Subject: **Bid No. 8819-M7 – Sprinkler & Fire Alarm Modifications – Union Station / WRA**

ADDENDUM NO. 3

SPRINKLER AND FIRE ALARM
MODIFICATIONS PHASE 2
UNION STATION
WORCESTER, MA

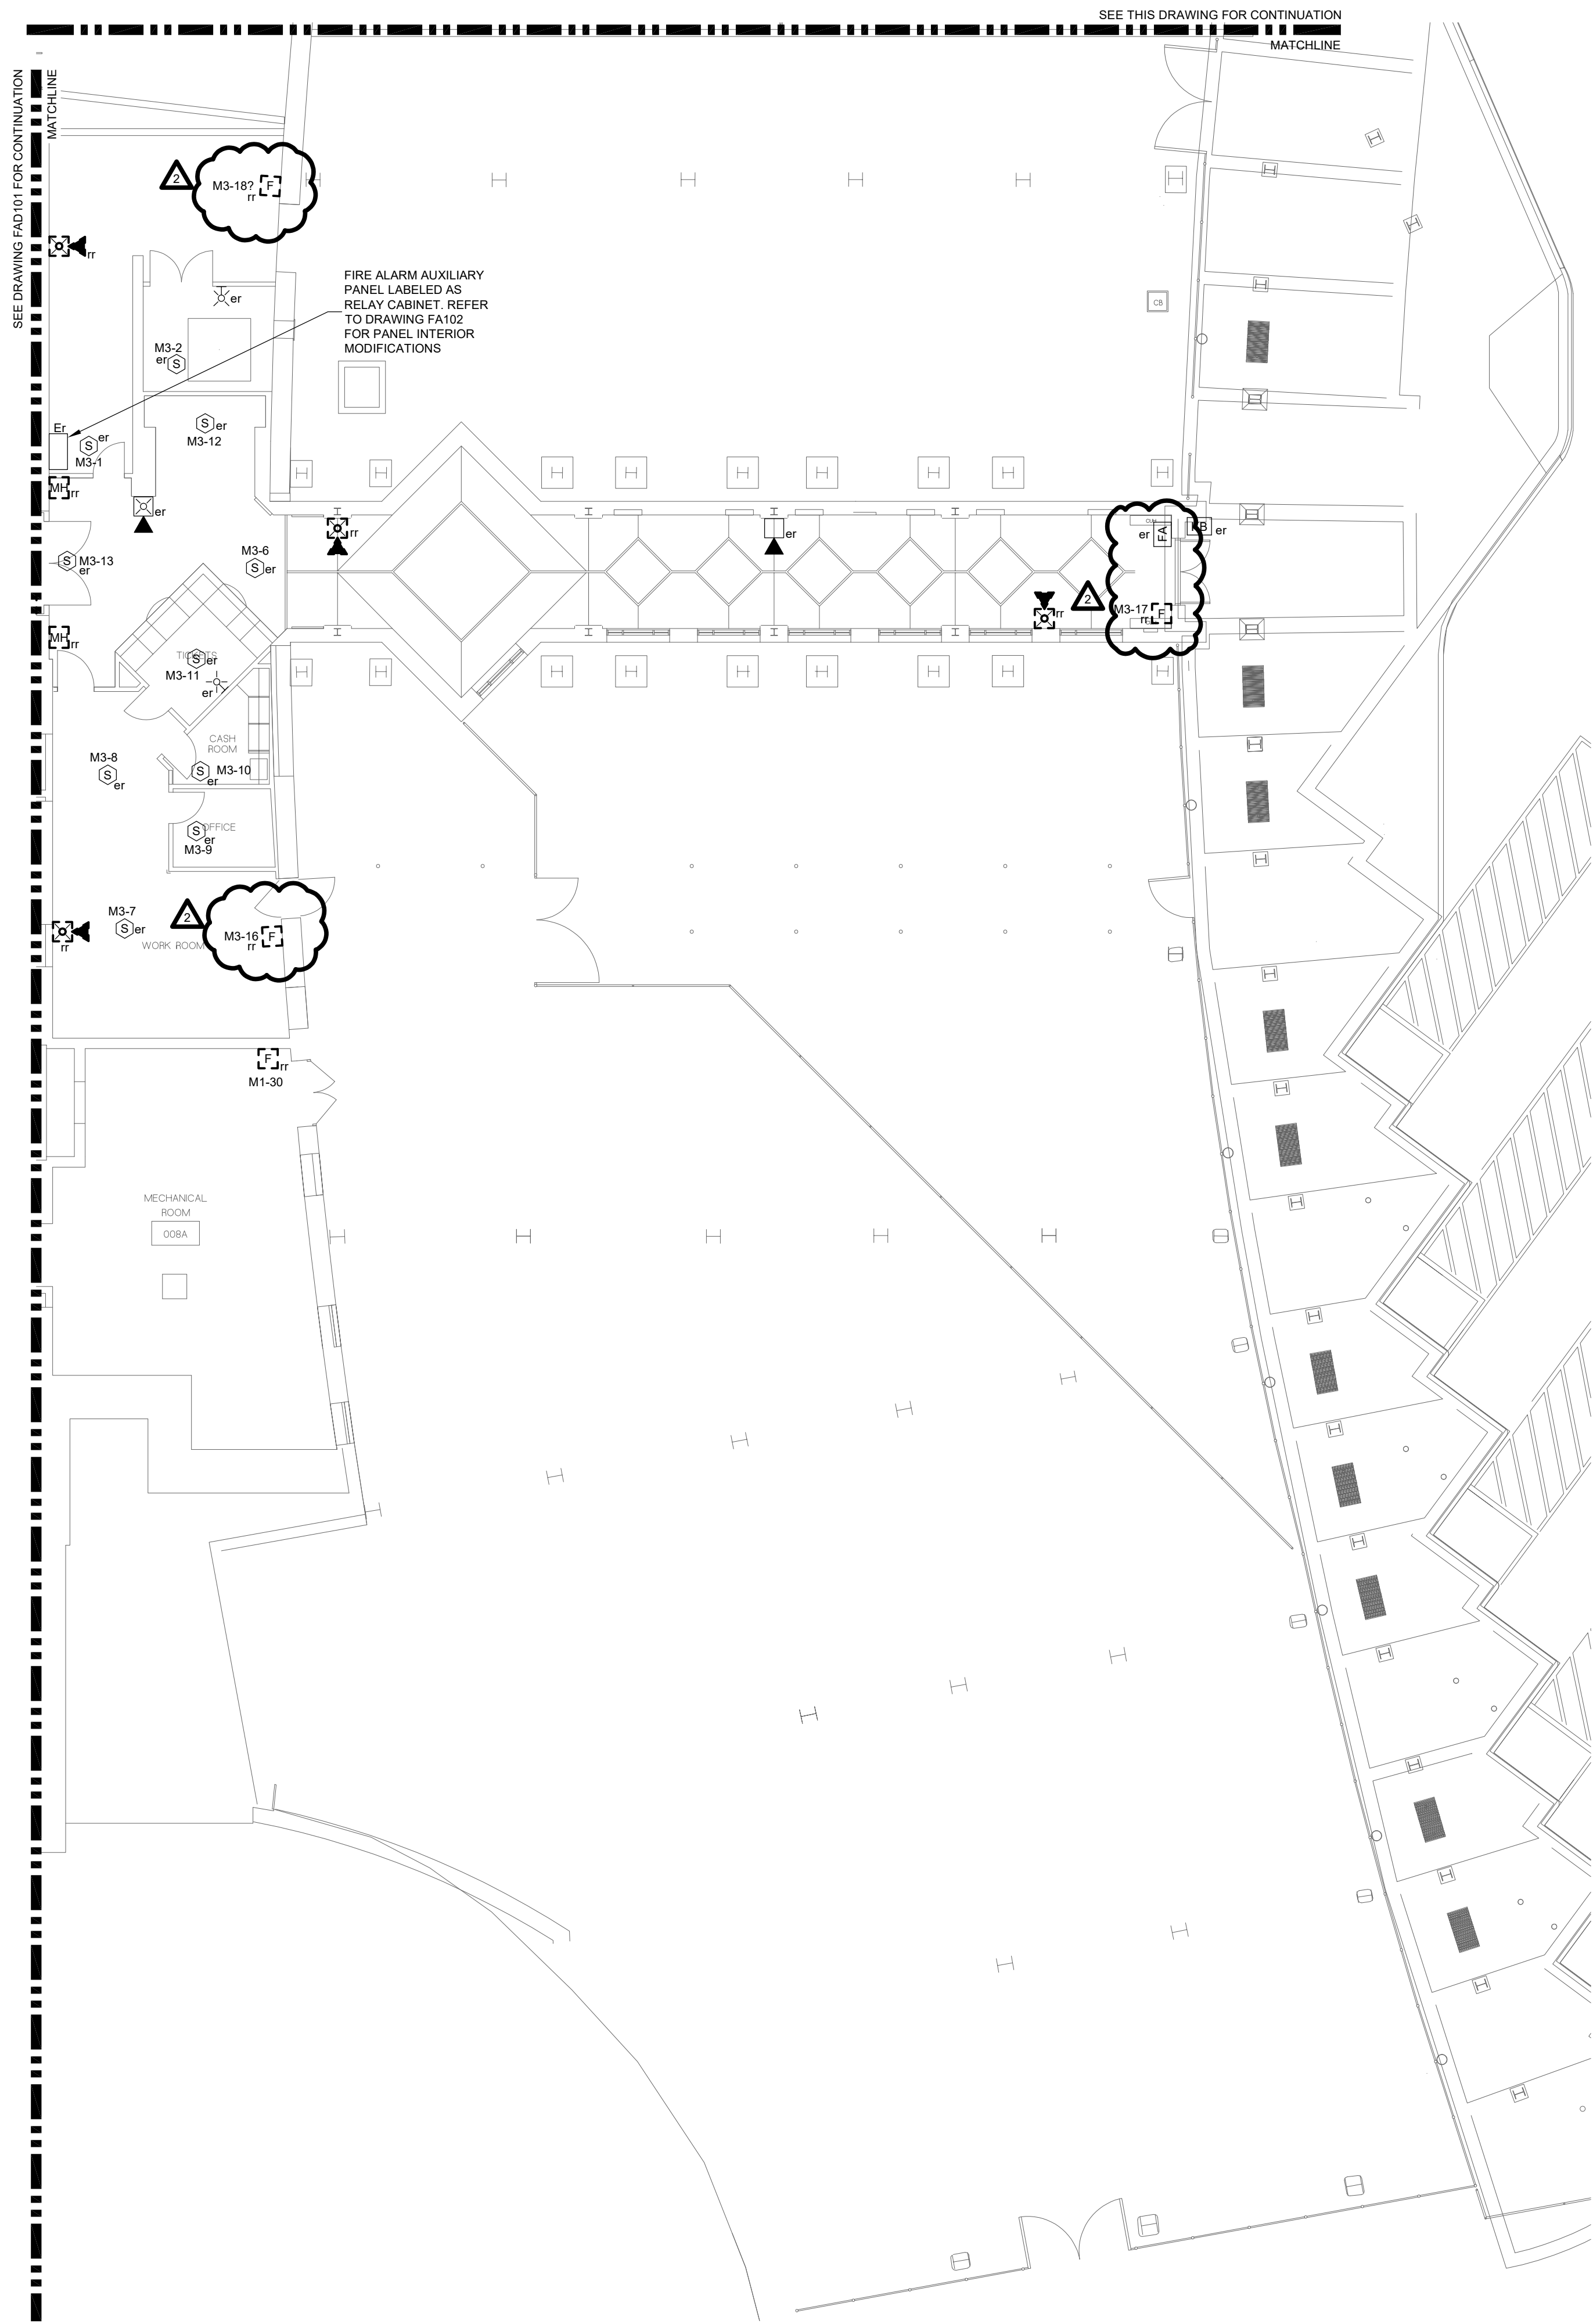
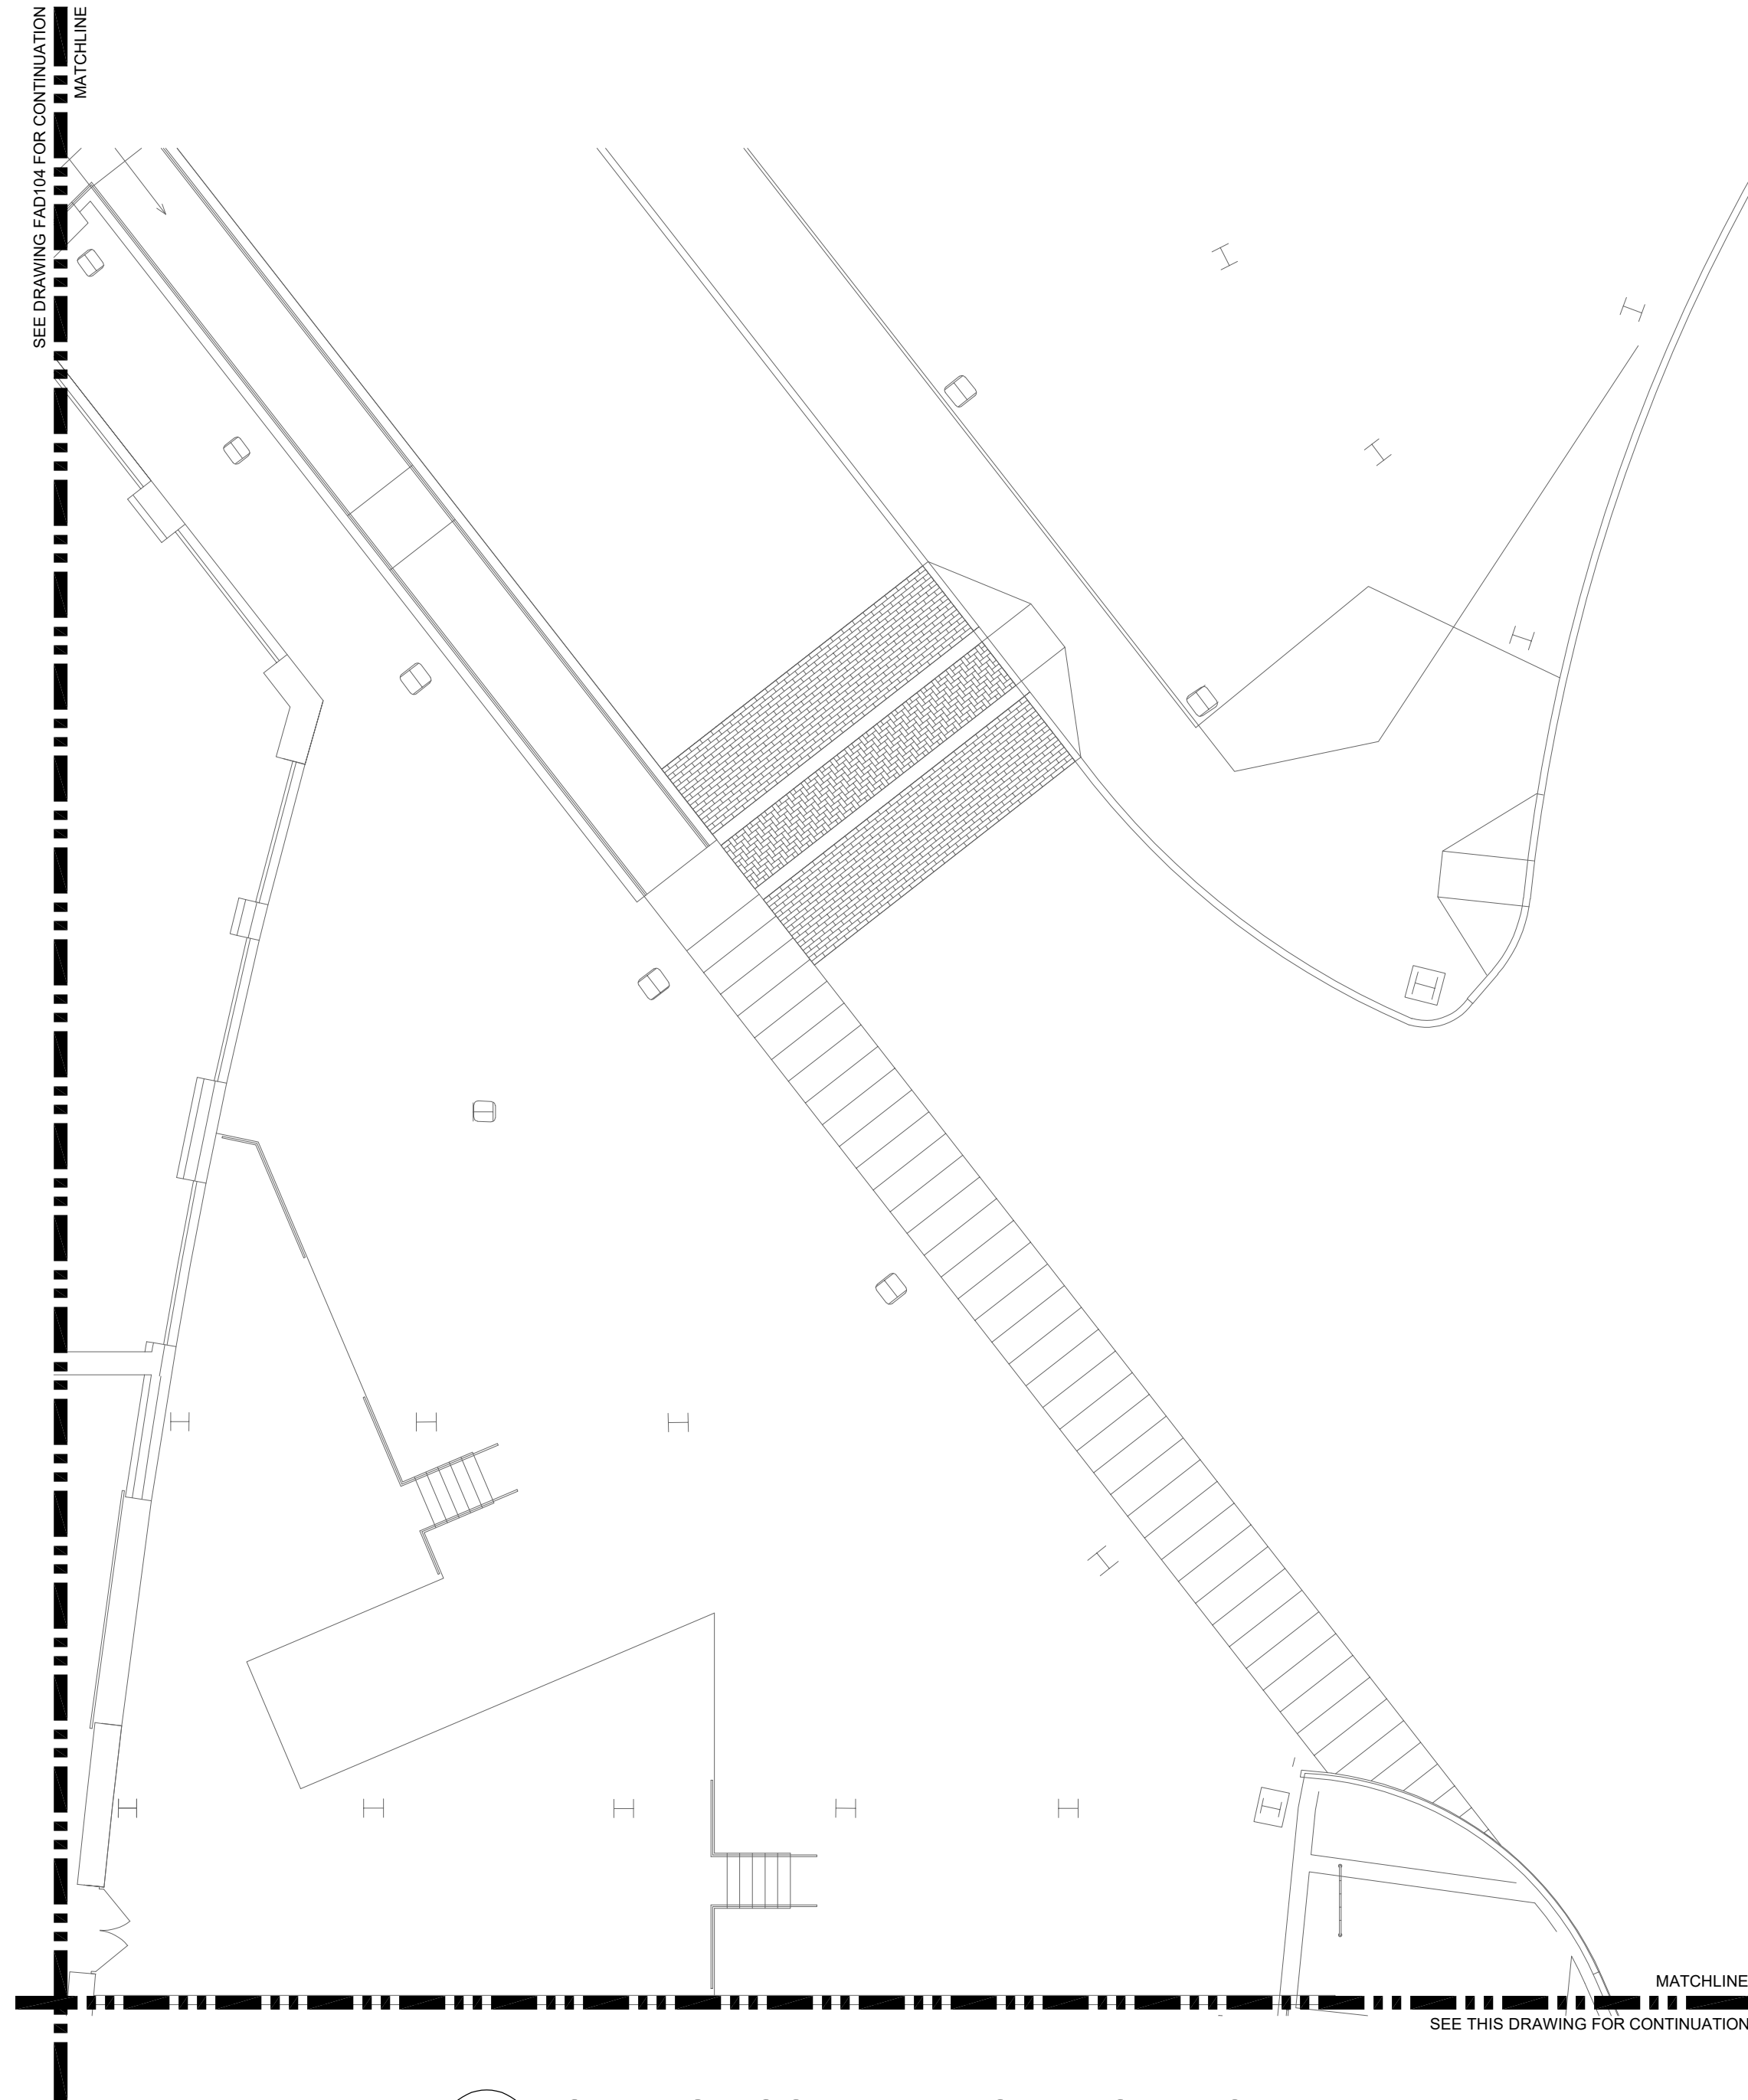
Drawing FAD102, Electrical Fire Alarm Partial Basement and Bus Terminal Demolition Plan, Revise as follows:

- REVISE three pull stations from “Existing to Remain” to “Remove and Replace”.
- REVISE fire alarm annunciator panel to be “Existing to Remain”.

Q: RFI response issued with Addendum 2 states "annunciator panels at the Harding Street exit and at the bus terminal exit shall be existing to remain" (and mentioned "Harding Street exit" AND "bus terminal exit." FAD102 shows one (1) "FA" annunciator device with "rr" notation (remove and replace); and FA102 has notation "nr" next to the same annunciator device. Please clarify scope.

A: Revision to previous Addendum response is as follows: There are no current annunciator panels at Harding Street exit and no new annunciator required. The annunciator at the bus terminal exit shall be existing to remain.

FAD103

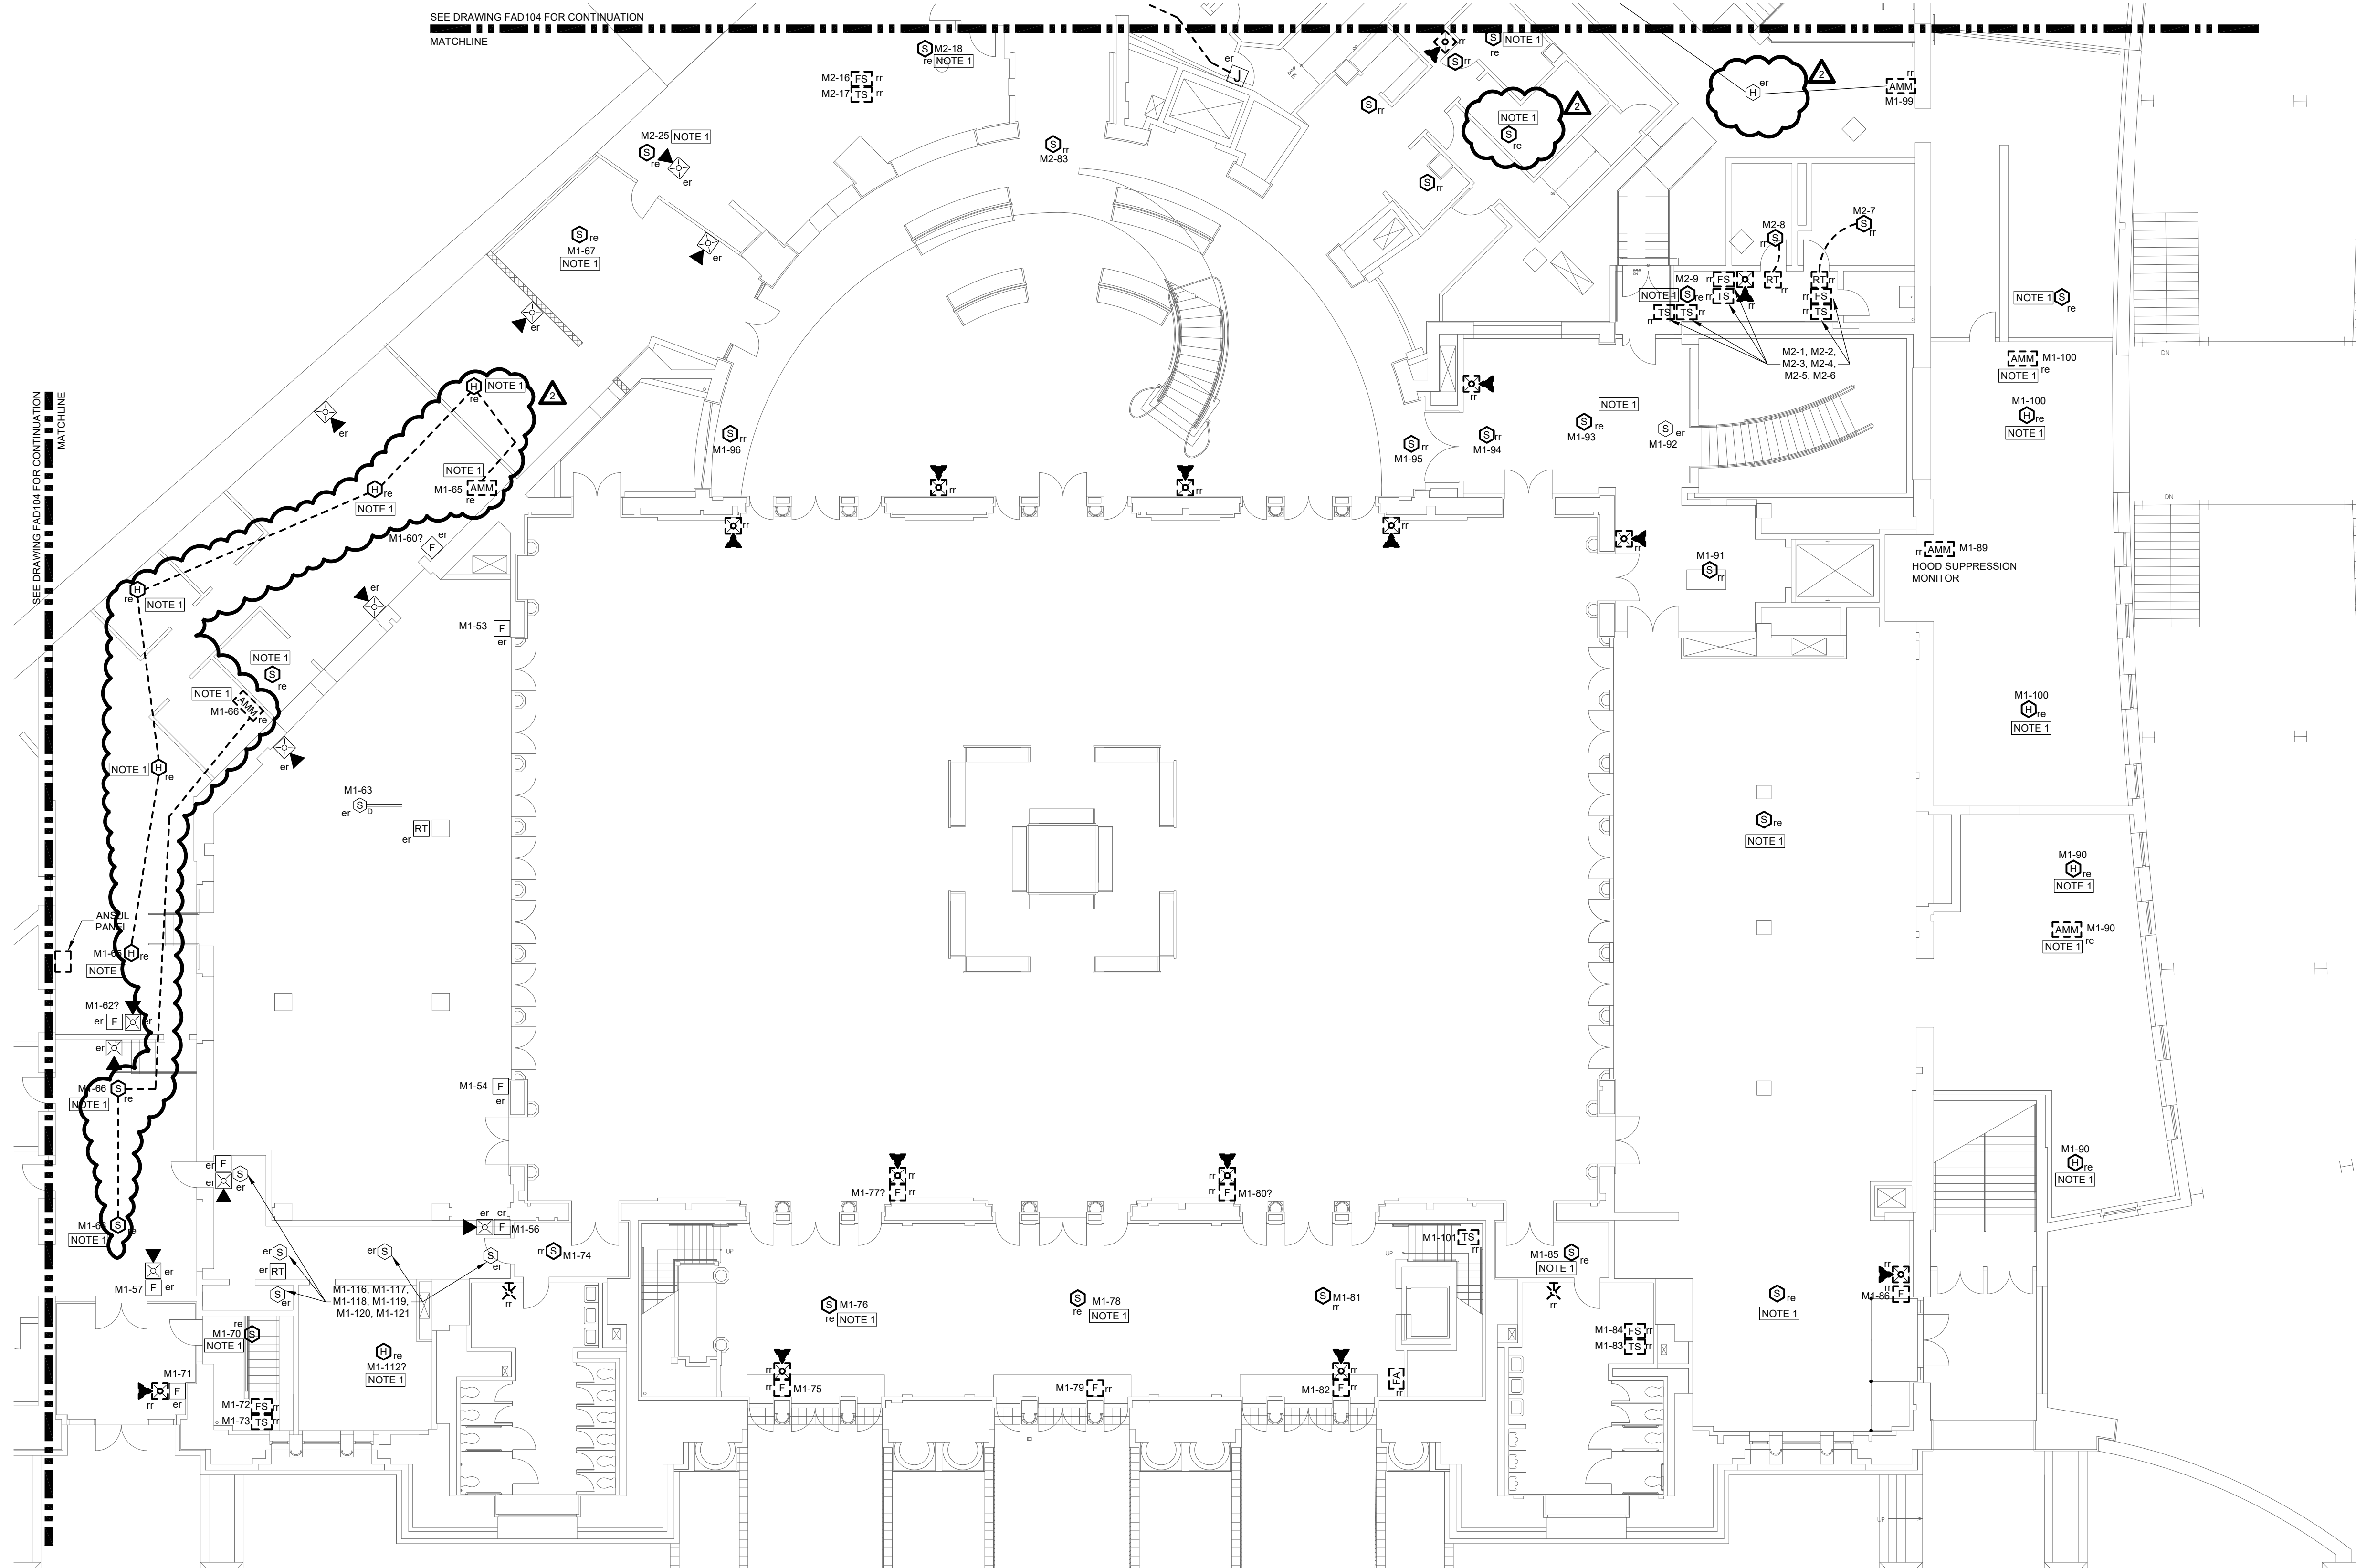
Drawing FAD103, Electrical Fire Alarm First Floor Demolition Plan, Revise as follows:

- REVISE one smoke detector from “Remove and Replace” to “Remove Existing”.
- ADD missing heat detector to remain monitored by addressable monitor module M1-99.
- REVISE wiring shown for heat detectors from addressable monitor modules for address points M1-65 and M1-66 to dashed line for demo and label associated modules to be “Remove Existing”.
